May 29, 2020

Re: Case No. ENV-2018-2116-EIR
Project name: Hollywood Center Project
Comments on Draft Environmental Impact Report

EXHIBIT A

Figure 1 – Veneklasen Receptor Location Map

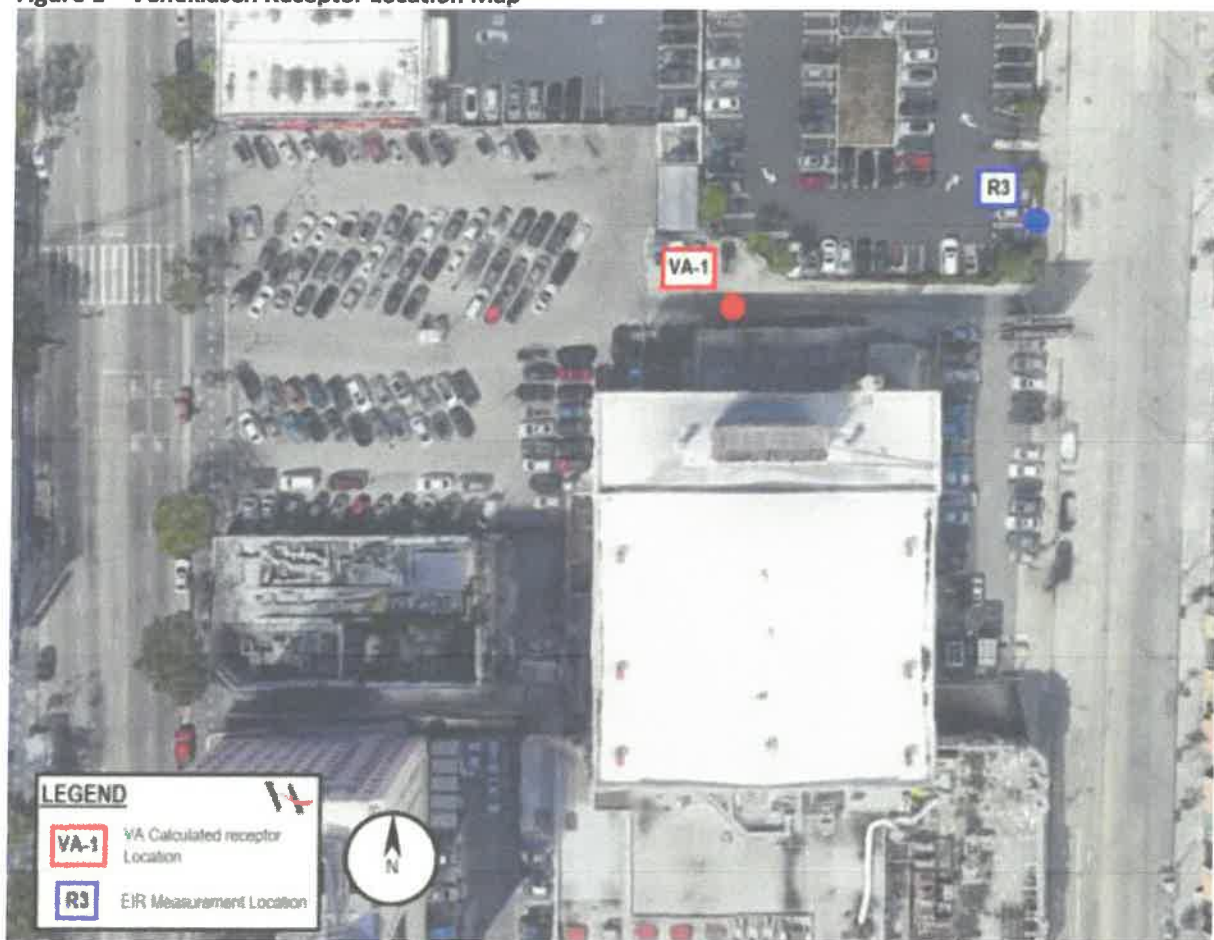
Draft EIR Page IV.I-21, Table IV.I-5: The measured noise level at measurement position R3 is not representative of the noise levels at the back of the Pantages Theater. The measured ambient level for the Pantages Theater indicated in Table 1, Appendix K-2 states that the measured level is 60.1 dBA at R3 along Argyle Avenue. This is not representative of the sound levels in the access alley behind the theater where there is some exposure to Vine Street, but also significant acoustical shielding because of building geometry which does not appear to be accounted for. Veneklasen performed a distance and angle attenuation analysis at Veneklasen receptor location VA-1 which is shown in **Figure 1**. Using the measured level at R3 along Argyle Avenue and the measured level at R2 on Vine Street, Veneklasen calculated the ambient noise level at VA-1 to be approximately 56 dBA, accounting for increased distance and reduced angle of exposure. As such, the significance thresholds identified in Table IV.1-19 and Table IV.1-10 for the Pantages Theater (receptor location no. 9) are significantly higher, which has the effect of understating the impact of construction noise on the Pantages Theater. Additional sound level measurements should be performed of suitable duration to determine the ambient levels in the alley behind the Pantages Theater. Veneklasen would suggest a minimum measurement duration of 72 hours during normal weather conditions.

Additionally, once the subject project is constructed, the alley behind the Pantages will be completely shielded from Vine Street, and the angle of exposure to traffic noise from Argyle Avenue will be further reduced, likely causing the noise levels to decrease further. Veneklasen estimates the post-construction ambient noise level in the alley behind the Pantages Theater to be approximately 47 dBA.

Figure 2 – Background Music Distance Attenuation Locations

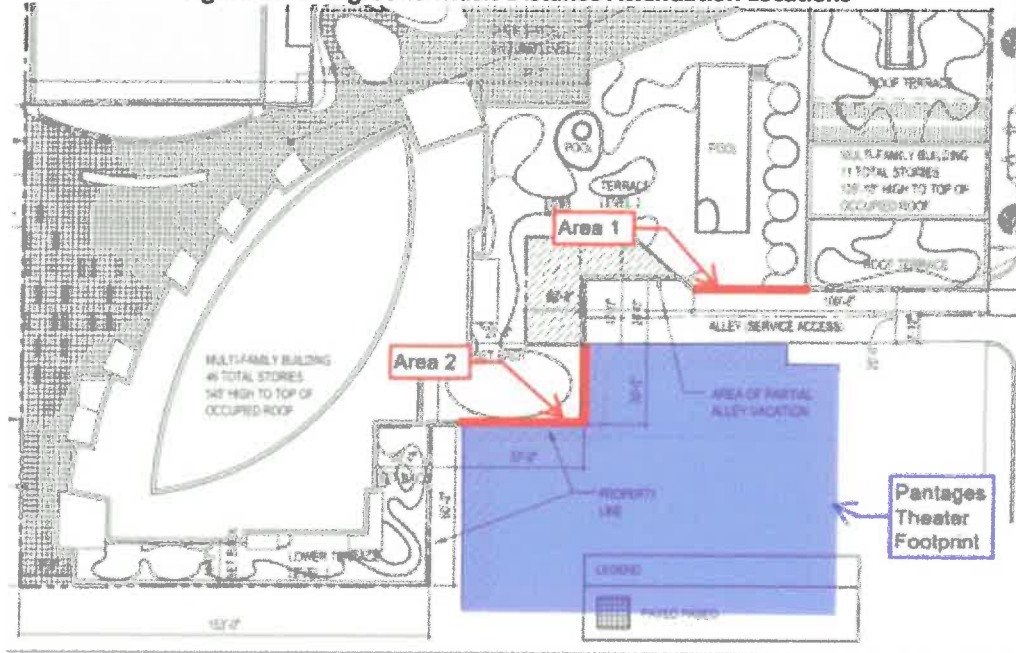
Draft EIR Table IV.I-12 and Page IV.I-51: On page IV.I-51 it is stated that the "sound level of the music speakers is conservatively assumed to be 75 dBA at 25 feet, which is more than 5 dBA higher than the ambient noise levels in the vicinity of the Amenity Deck (Level 2), East Site, which ranges from approximately 60.1 to 68.3." The predicted noise level pre-construction is 56 dBA and as stated in **Item I** above, Veneklasen predicts the post-construction noise level from Argyle Avenue to be about 47 dBA. Both predicted pre-construction and post-construction noise levels are significantly lower than the assumed 60.1 stated in the Draft EIR indicating that additional review and analysis should be performed. The areas from which Veneklasen performed a distance loss calculation between the Amenity Deck (Level 2), East Site and the Pantages Theater are shown in **Figure 2** below:

The distance from Area 1 to the Pantages Theater is 20 feet and the Distance from Area 2 to the Pantages Theater is 0 feet. For the purpose of an accurate analysis, Veneklasen has assumed a minimum distance of 5 feet from the nearest music speaker for Area 2. The results of these calculations are shown in **Table 3** below:

Figure II-19 indicates that under the East Site Hotel Option, there will be a swimming pool located in Area 2 is as shown in **Figure 2** above. Using the same calculation methods to determine the sound levels from speech at the Pantages from this area, the noise level will be 80 dBA at the Pantages. This would be a significant on-going impact and this area cannot be occupied by a pool, as any operation will significantly exceed both proposed interior noise guidelines and could negatively impact rehearsals and other theater operations.

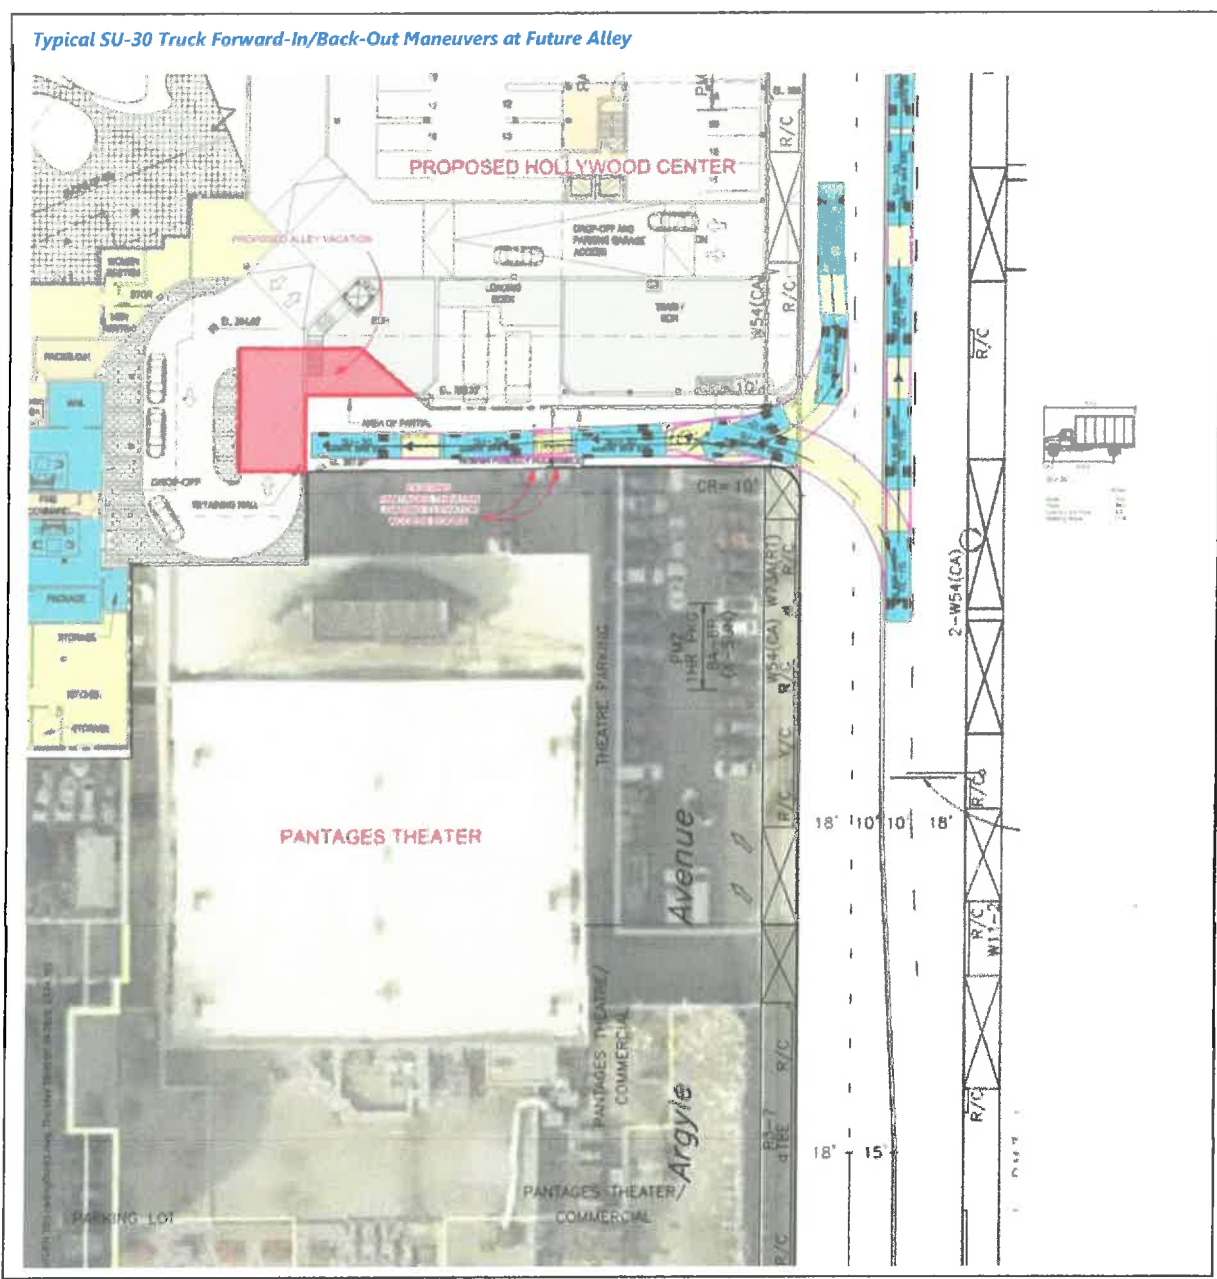
Figure 2D, which indicates that Project drop-off/pick-up area will occupy the vacated portion of the alley, is consistent with Figure II-14 in the Description of Project section of the DEIR, which indicates that this vacated portion of the alley is to have walls constructed separating it from the remaining alley, thus creating a dead-end condition for the shared alley with no turnaround space for service trucks. The alley turnaround area is currently used for daily delivery trips by the Pantages Theatre, trash pickups, and other services, and needs to remain usable without impedance. Under the existing conditions, standard single-unit trucks (SU-30) can utilize the turnaround area to depart without having to back out of the alley:

Under the proposed conditions, a typical SU-30 truck will no longer be able to turn around in this dead-end alley, and must back out of the alley driveway in order to depart, thereby adding even more truck movements on Argyle Avenue. Below is a typical scenario in which a SU-30 truck would have to maneuver in order to arrive and depart the alley:

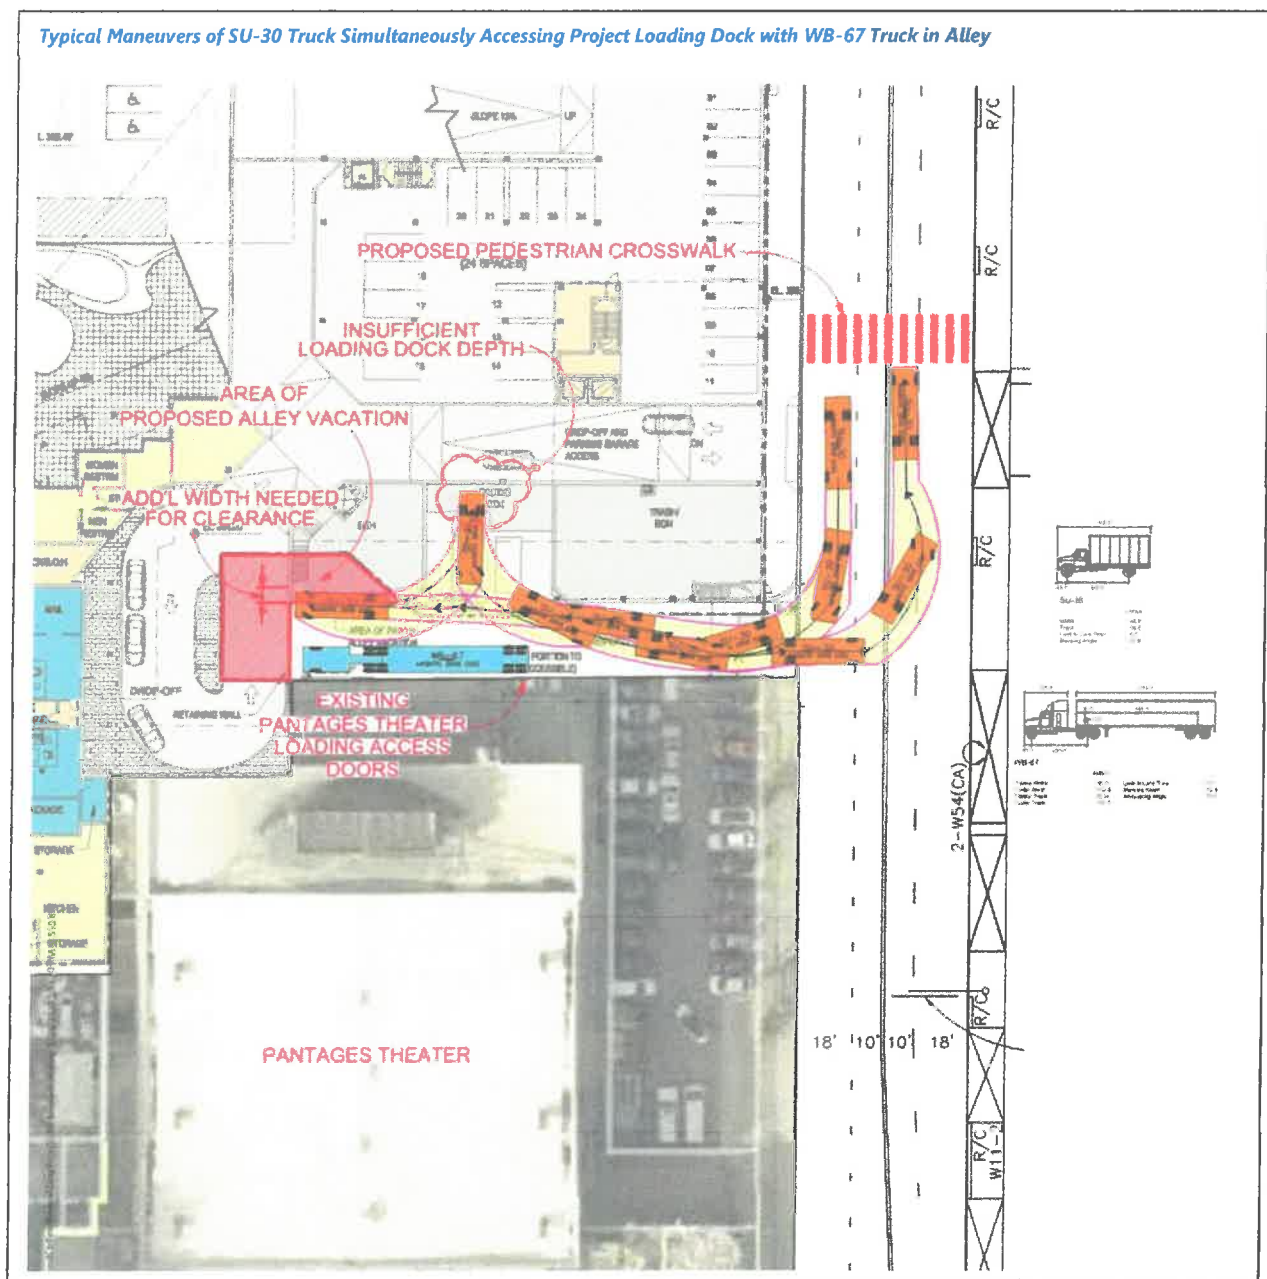
Below is a typical truck turn simulation for an AASHTO standard "WB-67" semi truck (73.5' bumper-to-bumper in length) maneuvering within the proposed alley limits for a forward-in and back-out scenario. The need for local delivery trucks to back out onto the street is exacerbated by having a parking structure entrance/exit on the opposite side alley driveway on Argyle Avenue. Trucks backing out to exit north will need to back in front of this driveway. It should also be assessed if the backing trucks will conflict with use of alley with service elevator for the Pantages Theatre.

Further, when trucks serving the Pantages Theatre occupies a portion of the currently proposed alley for loading and unloading, the Project loading dock is rendered inaccessible, as it does not have sufficient depth to accommodate the simultaneous uses that can occur within a shared use alley such as this one. An example of such a condition is shown below:

As shown above, in order for a SU-30 truck to access the project loading dock while a semi truck is positioned in the alley, additional width is needed in order for the su-30 truck to bypass the WB-67 semi

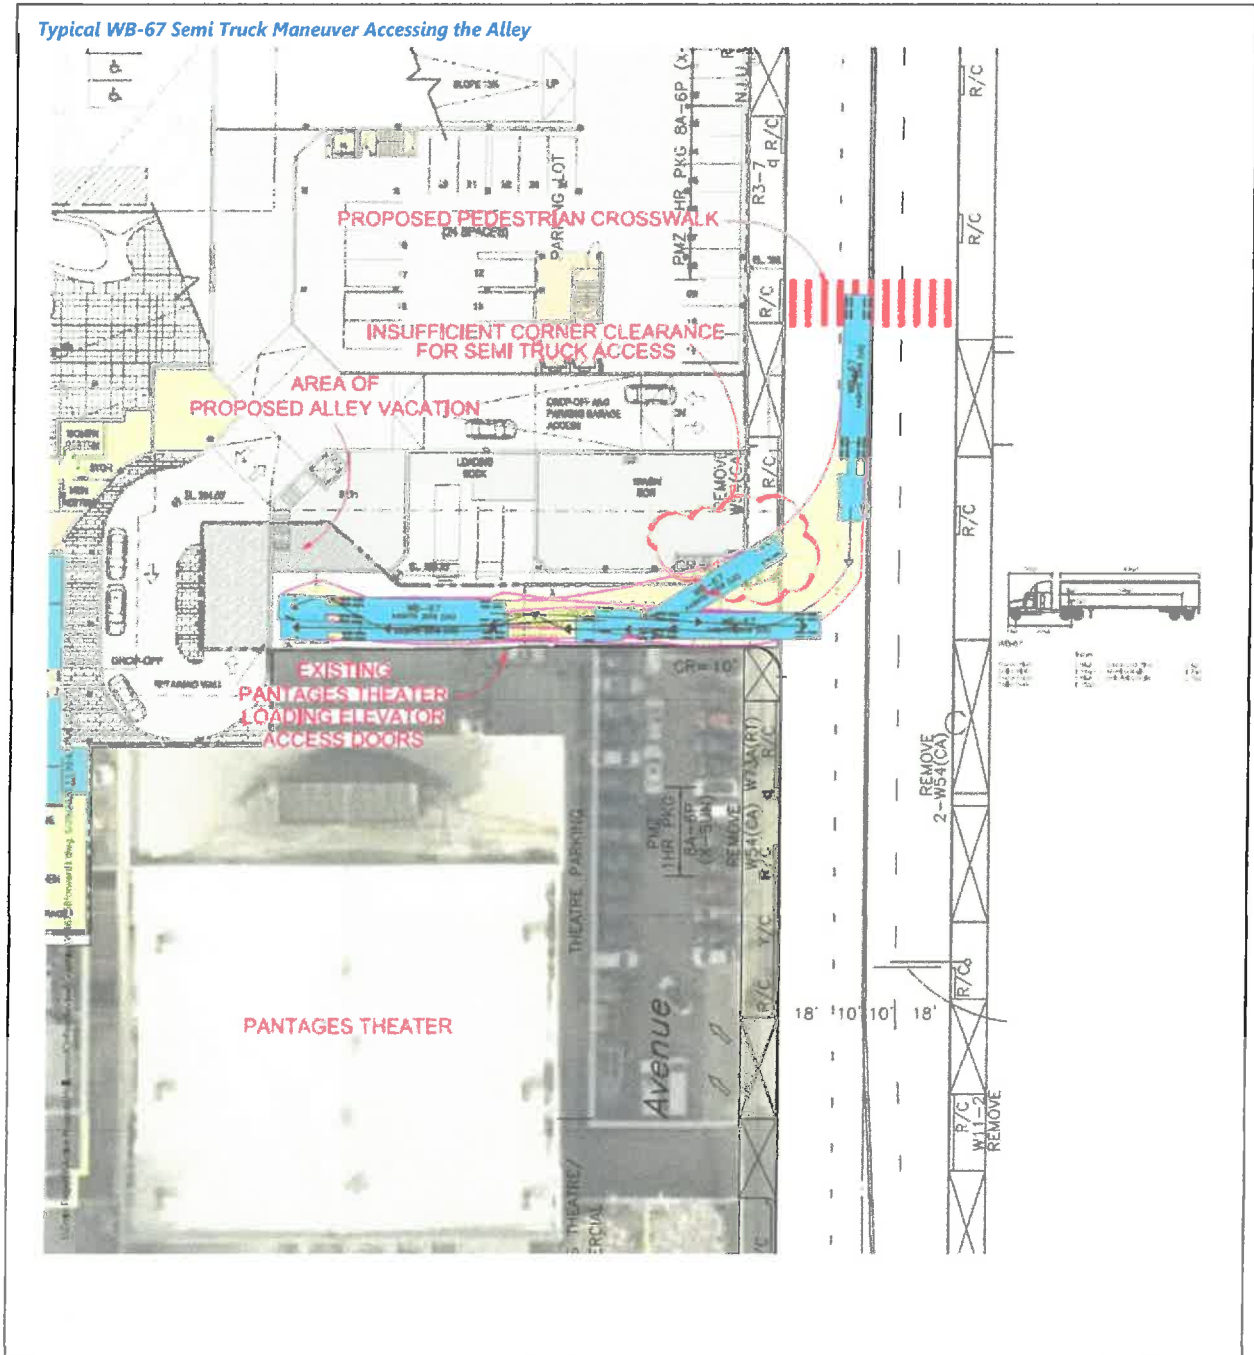
It is also noteworthy that the private driveway serving the Easttown mixed-use development (the east leg of the signalized intersection) is currently a right-in/right-out only driveway, with speed bumps and the eastern terminus of this driveway being gated and closed to through traffic:

These traffic signage were installed as part of the Eastown development at the request of LADOT. Typically, LADOT imposes left turn prohibitions to private driveways as a tool to reduce the amount of additional traffic added to an already congested roadway, or as a means to reduce the probability of potential traffic safety conflicts in that specific location. Vehicles exiting the Eastown driveway making left turns into a gridlocked traffic condition may block northbound traffic from flowing through while waiting for a gap in the southbound traffic. While common wisdom may deduce that having a signalized intersection that serves both the Project and the Eastown driveways would alleviate these concerns, the introduction of a new traffic signal will cause further delays on Argyle Avenue, as it will increase wait time. A comprehensive queuing and signal timing synchronization study, along with safety, and neighborhood traffic management analysis of Argyle Avenue and the Project driveway should be conducted, as queuing will be an added issue for a full signal with phases activated by automobiles exiting either driveway.

Based on those considerations, the following statement on Page 123 is not correct:
